**MINUTES OF
59th MEETING OF EXPERT GROUP ON ZOO DESIGNING
OF CENTRAL ZOO AUTHORITY
HELD ON 26th FEBRUARY, 2015**

c. Construction of enclosure for Sloth bear:

ENCLOSURE FOR SLOTH BEAR

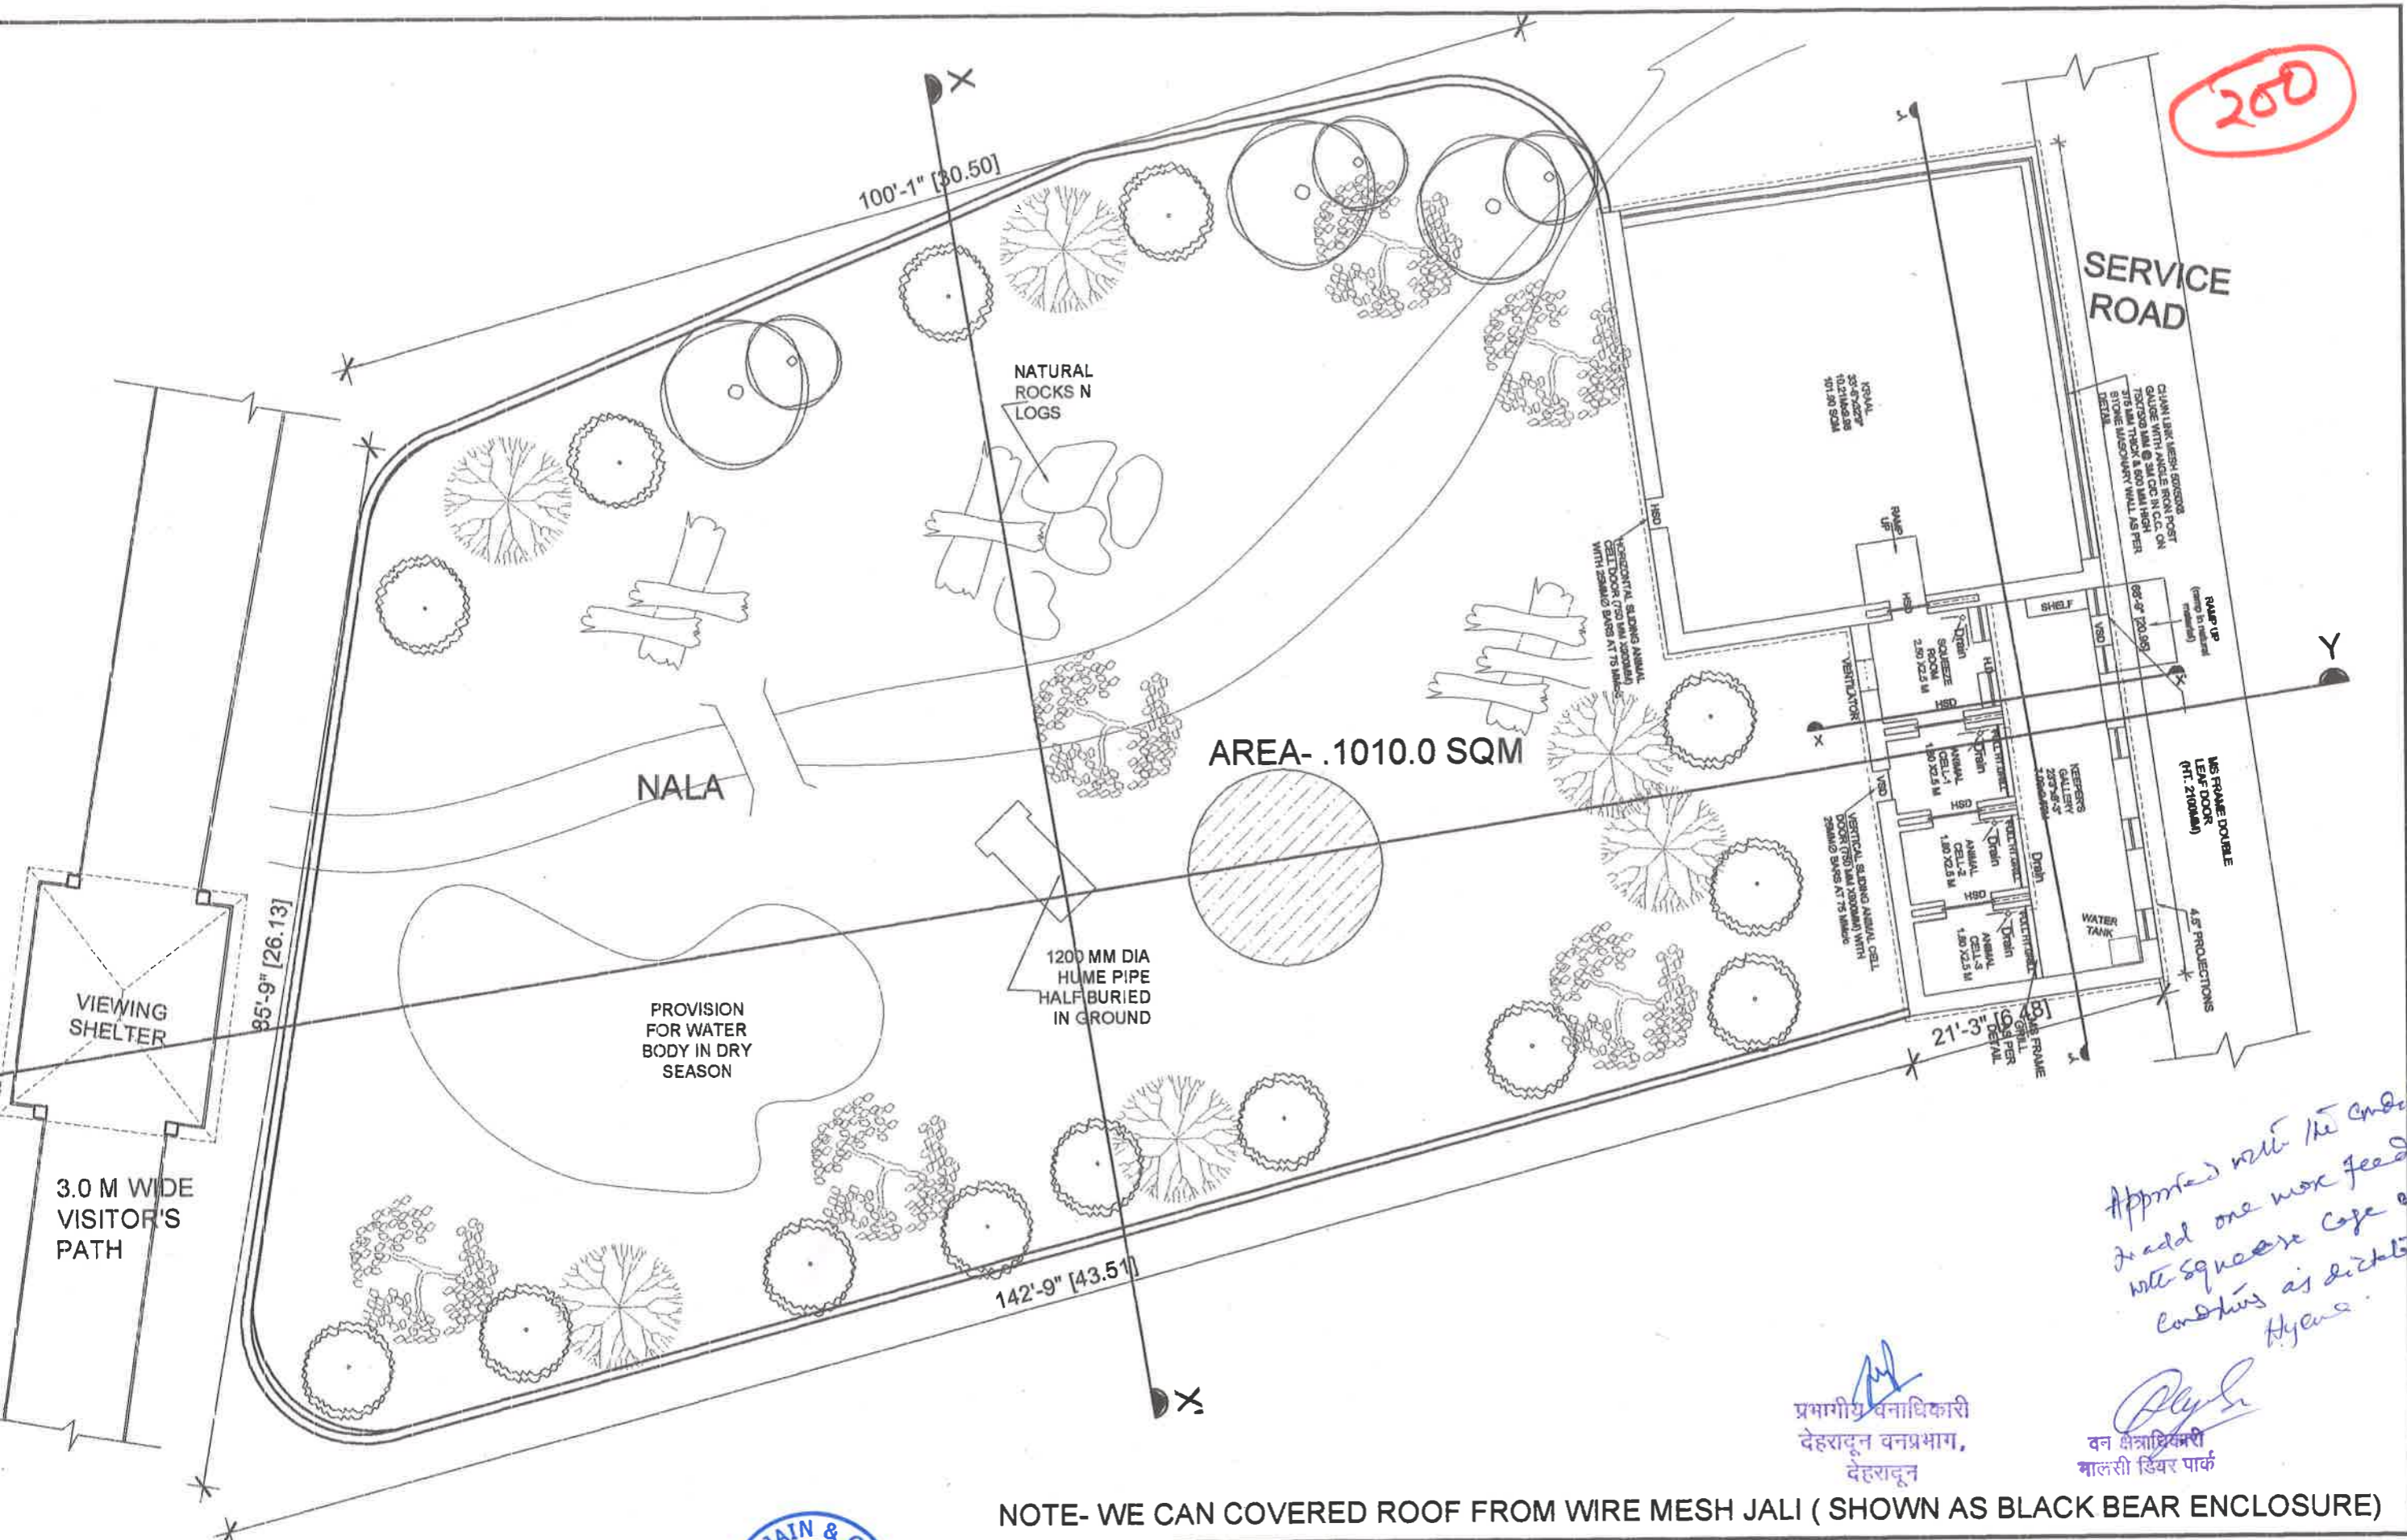
The design was scrutinized and approved subject to compliance of following conditions:

- i. Size of smaller water body may be increased to that of the larger water body, as mentioned in the design.
- ii. No viewing shelter is necessary. Plantation along visitors' path would serve the purpose.
- iii. Additional feeding cell having squeeze cage should be added on the side opposite to the kraal.
- iv. Paddock need not be covered on top. Therefore, no GI pipes / steel columns are required.
- v. The paddock barrier should be 4mts high chain-link fence with 1.5 mts wide mild steel plate overhang inclined inwards at an angle of 60°.

Approved with the condition to add one more feeding cell with squeeze cage & other contents as detailed for Hygiene.
